Abnormal XRF on 10.1016/j.dwt.2024.100473

5GH Foundation**10.1016/j.dwt.2024.100473, Figure 9**

Title: Switching of iron coagulants from steel residue for wastewater treatment

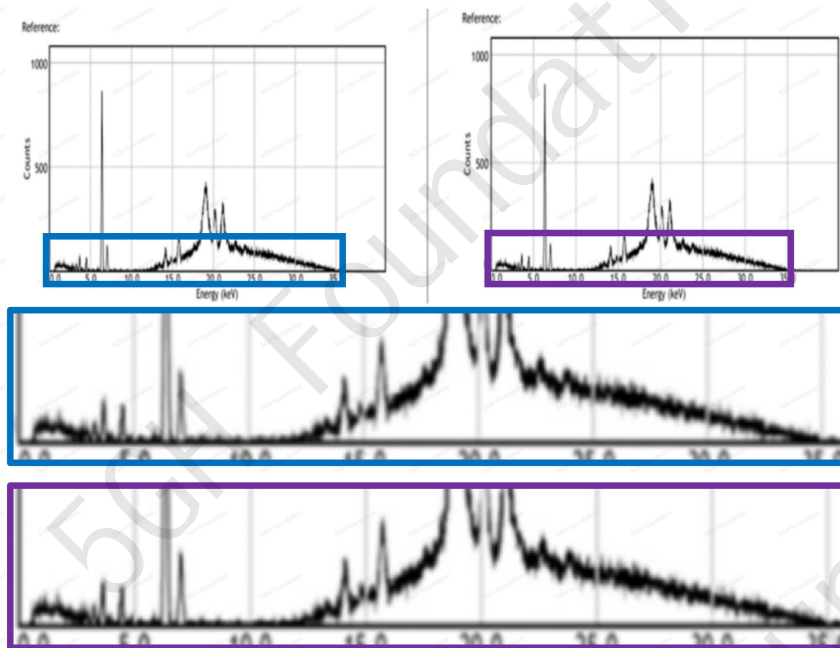
The XRF patterns on the Figure 9 of the article [1] are identical to each other.
